MANDATORY SERVICE BULLETIN

NUMBER: SB-022

REVISION: B

SUBJECT: PITOT STATIC SYSTEM; MANDATORY MODIFICATION

Pitot Static Re-Route Drill Plate (P/N 100-210-1604-0015)

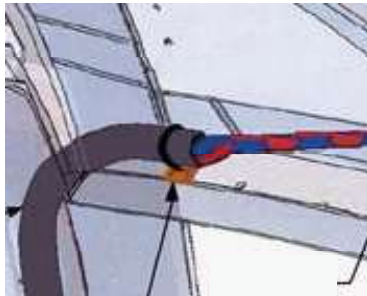
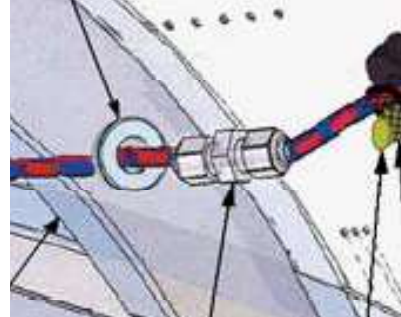
6	Cleco the Pitot Static Re-Route Drill Plate tool (P/N 100-210-1604-0015) to the frame (P/N 100-210-1604) and drill a 1/8" hole. This will locate the new 3/4" hole per Figure 3. Remove clecos and Pitot Static Re-Route Drill Plate. Upsize the hole to 0.750" +/- 0.010" 
7	Install a rubber grommet (P/N MS35489-149) (Item #11 see Figure 7) in the new hole. NOTE: On the right side of the cabin, slide rubber grommet back into existing hole to protect the wiring.
8	Feed the pitot static tubes aft through the new hole.

Figure 8

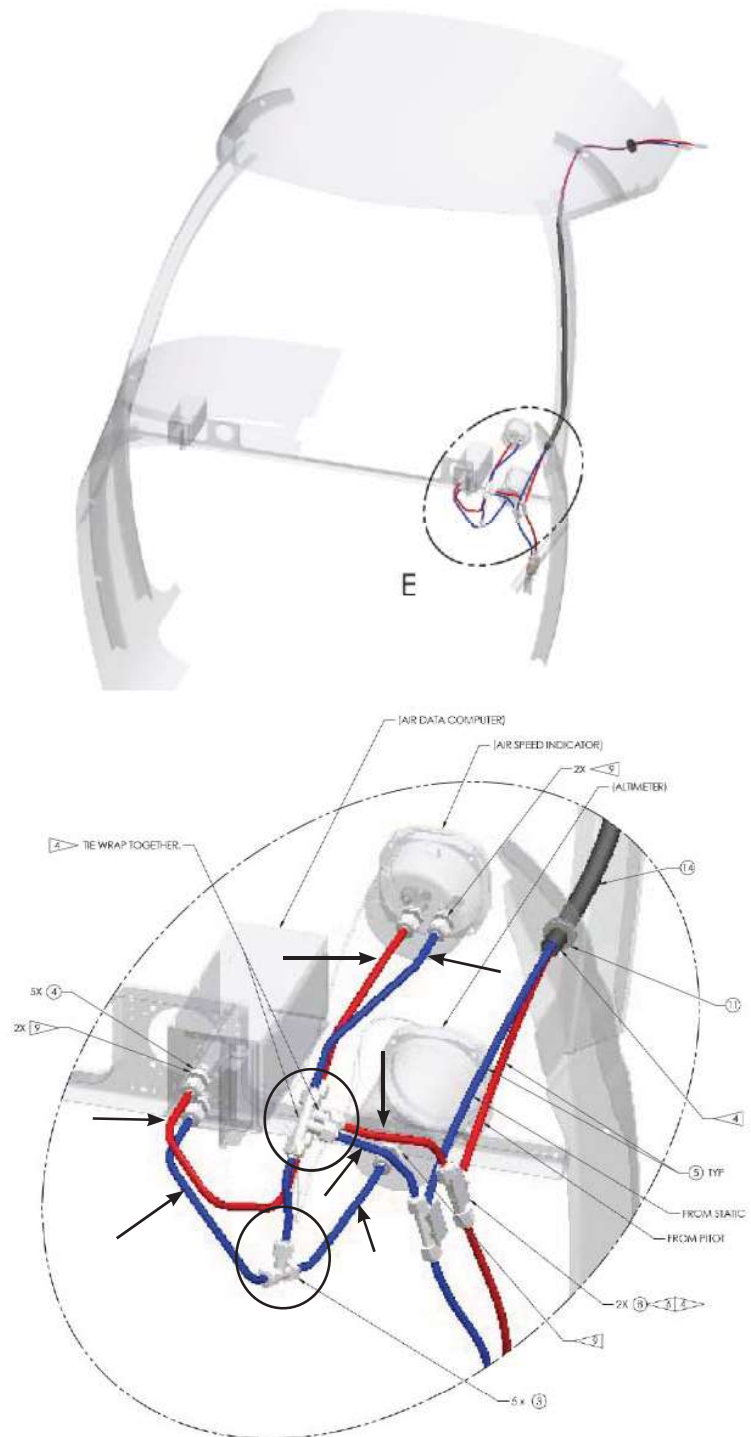
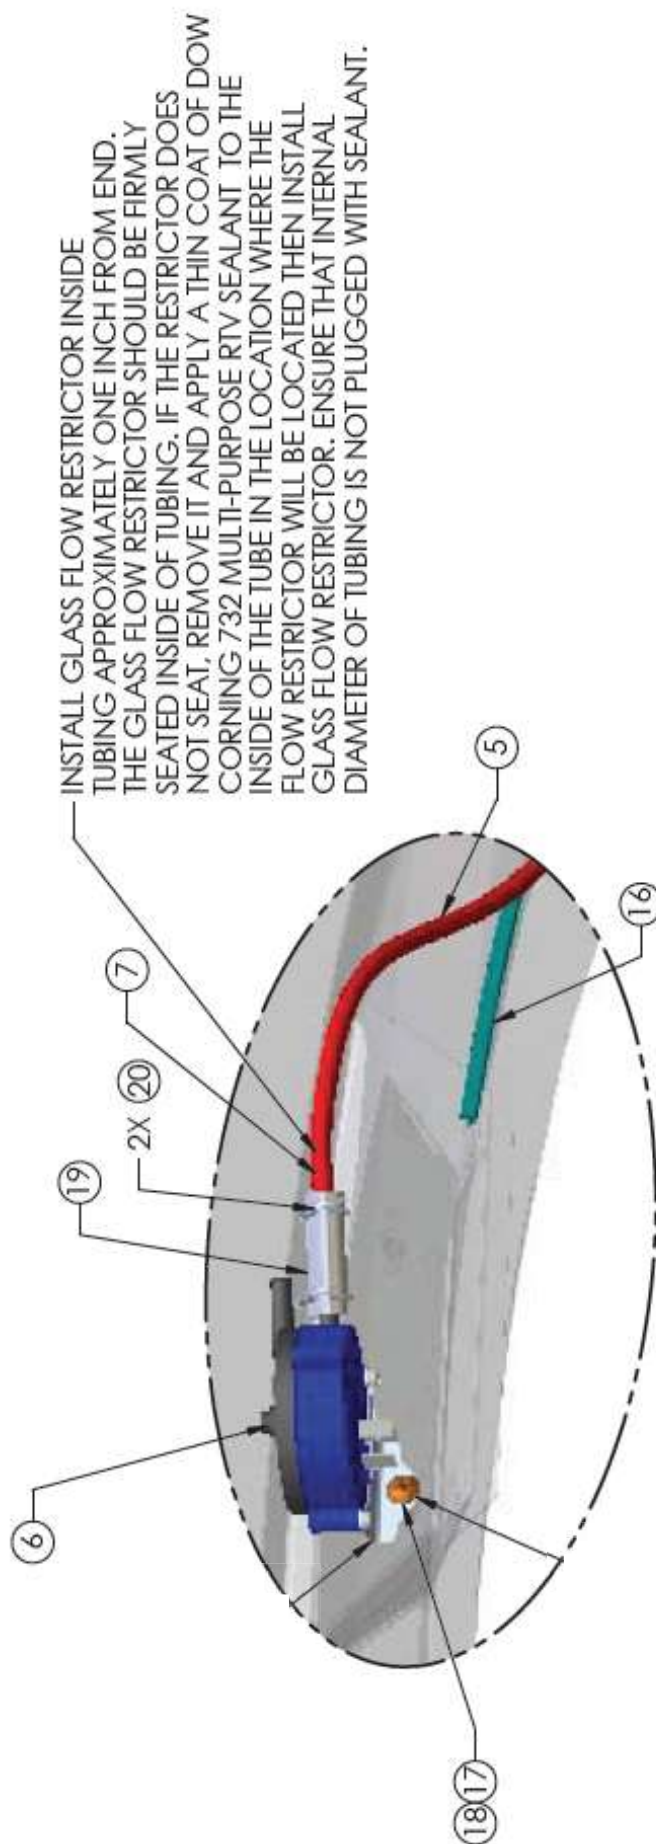
Identify and remove the pitot static tubing indicated in **Figure 8** (LH Side).

NOTE: Be sure to remove the insert stabilizers from the removed tubing and reuse at each connection.

Figure 10

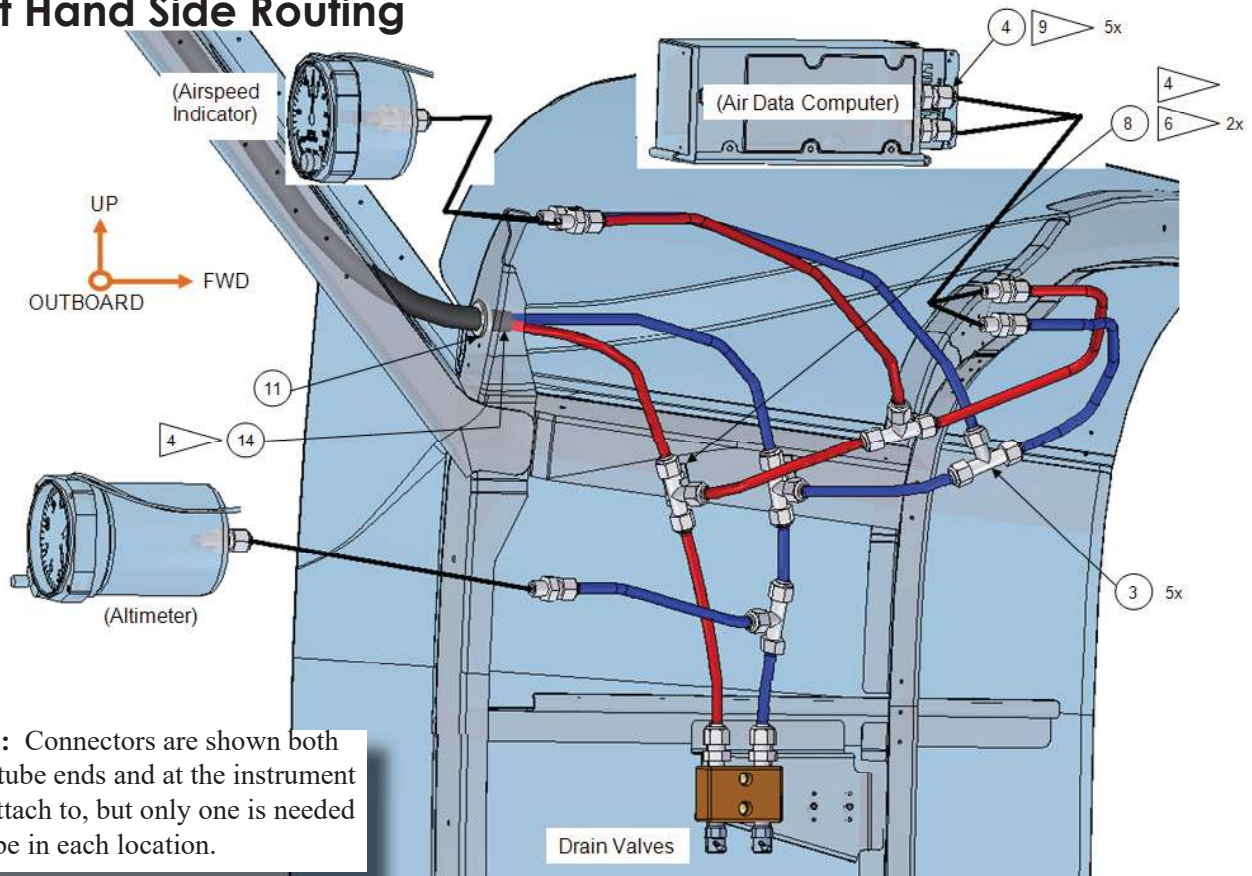
Pitot Static Low Point Mitigation		
Task	Instruction	
14	Identify and remove the pitot static tubing indicated in Figure 9 (RH Side). Remove Center Garmin display and set aside. This will allow access to the Air Meter Switch. NOTE: Be sure to remove the insert stabilizers from the removed tubing and reuse at each connection. NOTE: Be careful not to lose or damage the glass Flow Restricter within the tube near the Air Meter Switch (see Figure 10).	(RH) SIDE ROUTING SHOWN Figure 9
15	Reroute the pitot static tubing under the Left Hand dash per Figure 11 and Figure 13. NOTE: For a detailed schematic of routing see Figure 12.	
16	Reroute the pitot static tubing under the Right Hand dash per Figure 10, Figure 12 and Figure 14. NOTE: For a detailed schematic of routing see Figure 14.
